SK hynix Inc.	Firmware Change Notification			PCN No.	F1611-031-N-00
				Date	2016-11-22
PCN Title	FCN for 1ynm eMMC5.1			Description of Change	(I) Change Command Queue handling policy (Aligned with Qualcomm policy) ※ Change Value of Ext_CSD relative to Time Out (GENERIC_CMD6_TIME [248] and SLEEP_NOTIFICATION_TIME [216])
Purpose	Change CMDQ handling policy PRV value: 0xA5 ※ Change Datasheet Value of ext_CSD relative to Time Out				
Customer	ALL				
Device	1ynm eMMC5.1 / eMCP5.1				
Part No.	221Ball eMCP5.1 Product : H9TQ64A8GTCCUR (8+8) H9TQ17AAETACUR (16+12) / H9TQ17ABJTACUR (16+16) H9TQ17ABJTBCUR (16+16) / H9TQ17ADFTACUR (16+24) H9TQ26ABJTACUR (32+16) / H9TQ26ADFTACUR (32+24) H9TQ26ADFTBCUR (32+24) / H9TQ26ACLTMCUR (32+32)				
Remark	1ynm based eMCP5.1 - Change CMDQ handling policy PRV 0xA5 - Ext_CSD (CMD6 generic / Sleep Notification)			Date Issued : 2016-11-22 Prepared by : Y.E. Cho E-mail : youngeui.cho@sk.com Checked by : K.L. Park EMMC Quality Engineering Project Approved by : VP H.G. Lee Solution Quality Group

SK hynix	Firmware Change Notification	FCN # : F1611-031-N-00 Date : 2016-11-22
1. Customer : All	2. Device : 221Ball eMCP5.1 Product : H9TQ64A8GTCCUR (8+8) H9TQ17AAET

▪ Firmware Change Note (I)

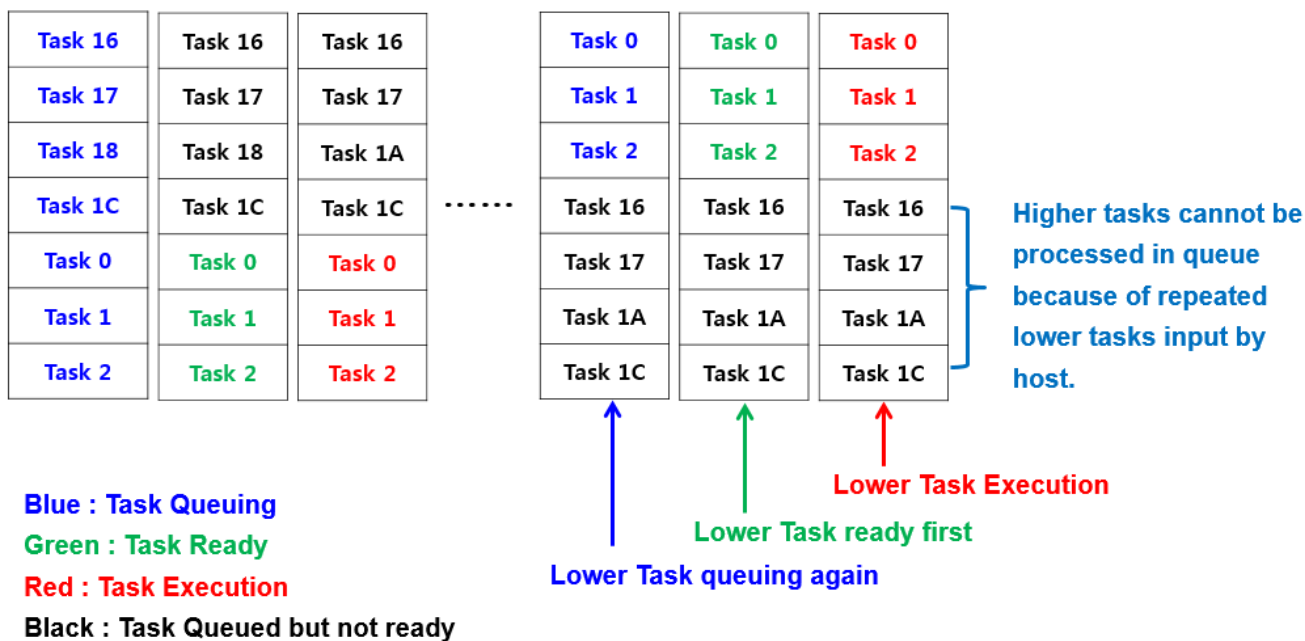
- Change Command Queue handling policy

✓ Root Cause

: **Timeout occurs because command queue handling is not aligned with Qualcomm policy.**

eMMC processes lower number tasks while higher number tasks are waiting in queue

and host sends lower number tasks repeatedly, so higher number tasks cannot be processed within host timeout (120 sec.).
